TO: All U.S. Ford and Lincoln Dealers

SUBJECT: Customer Satisfaction Program 22B34

Certain 2021-2022 Model Year F-150 Vehicles Equipped with 9.75" HD Axle – ¾ Float Axle
 Rear Axle Half-Shaft and Hub Assembly Replacement

FIGURE 1

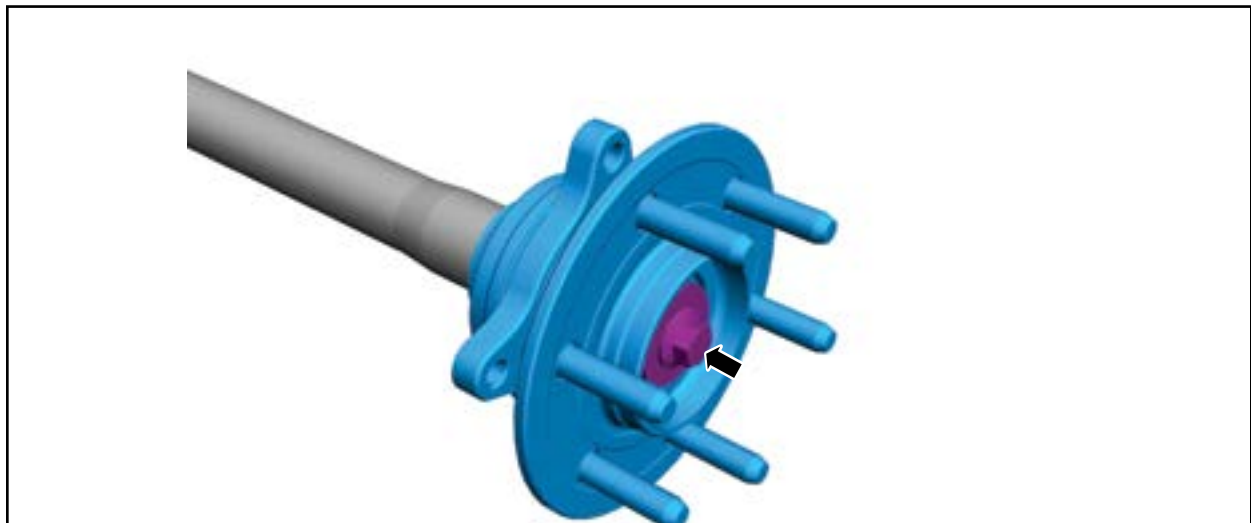
1. Position the vehicle on a hoist. Please follow Workshop Manual (WSM) Procedures in Section 100-02.
2. On both sides, remove the rear tire to prevent any possible scratching. Please follow Workshop Manual (WSM) Procedures in Section 204-04A.
3. On both sides, locate the rear wheel end hub bolt. See Figure 1.
